From: Allen, Jennifer (02) <Jennifer.Allen2@balfourbeatty.com>
Sent: 12 January 2021 08:12
To: Jenman, Rebecca <Rebecca.Jenman@herefordshire.gov.uk>
Cc: Hockenhull, Joel <Joel.Hockenhull@balfourbeatty.com>
Subject: 183198 - Trevase Farm, St Owens Cross, Hereford, HR2 8ND

SITE: Trevase Farm, St Owens Cross, Hereford, Herefordshire HR2 8ND
TYPE: Planning Permission
DESCRIPTION: The proposed erection of three additional poultry units, amenity building, feed bins, new site access and access track and associated development on land to the east of the existing poultry units plus the installation of side chimney fans to the existing four poultry units
APPLICATION NO: 183198
GRID REFERENCE: OS 351393, 225697
APPLICANT: Mr D Pursey
AGENT:

Figure 1: Environment Agency Flood Map for Planning (Rivers and Sea), September 2018

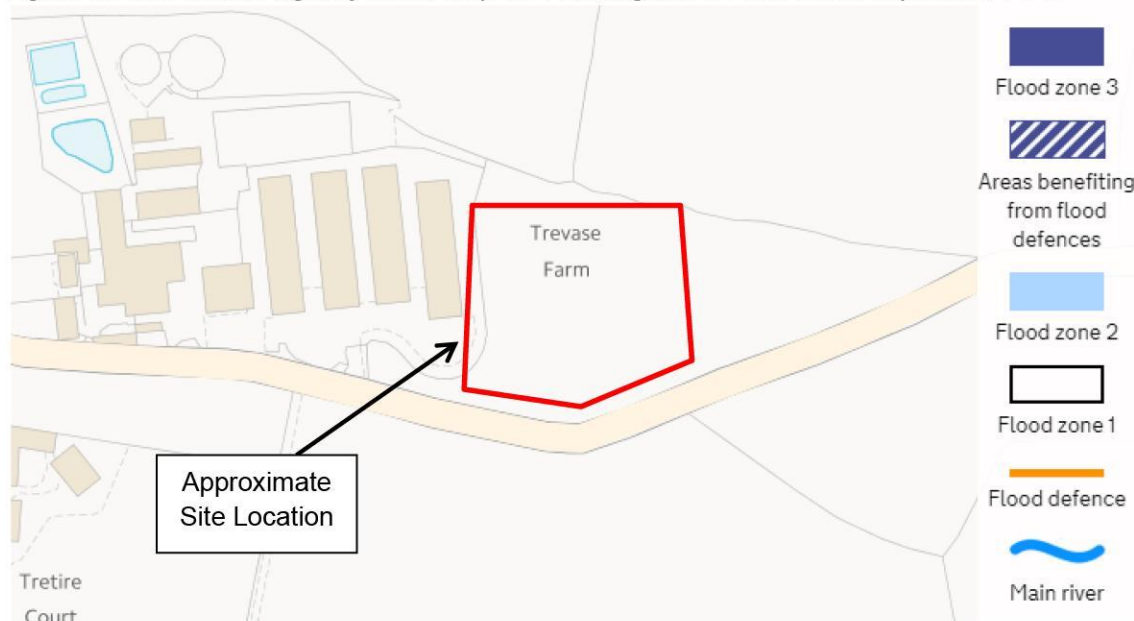
Review of the Environment Agency's Flood Map for Planning (Figure 1) indicates that the site is located within the low risk Flood Zone 1.
